COMMONWEALTH of VIRGINIA

September 17, 2010

MEMORANDUM

To: All Holders of the Virginia Department of Transportation's 2008 Road and Bridge Standards

REVISION DATE SHEET 1 OF 3 08/10 114.01

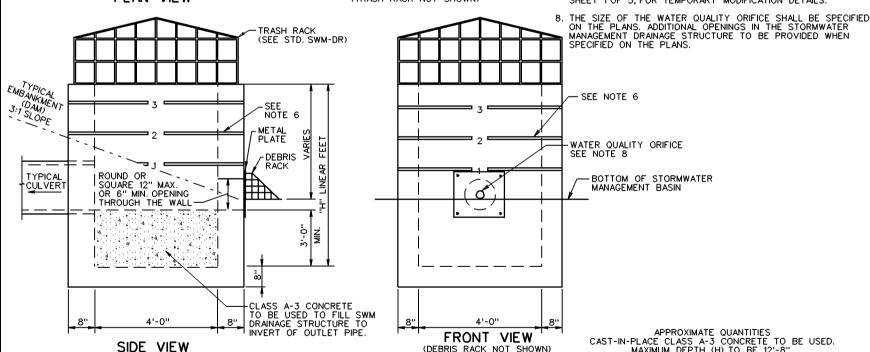
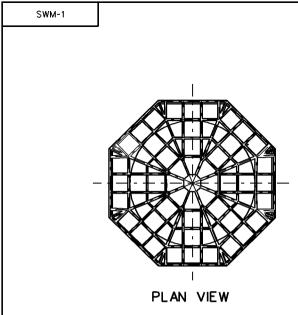
PAGE	REVISION
104.09	Clarified Type B nose detail note
114.01	Corrected note callout
114.02	Corrected note callout
501.11	Clarified note C and section callouts
501.16	Clarified note C
501.18	Clarified direction of traffic
501.19	Corrected description for one way traffic
502.21	Changed note 5 from "shall be" to "may be"
502.22	Changed note 5 from "shall be" to "may be"
603.02	Clarified exit taper ratios
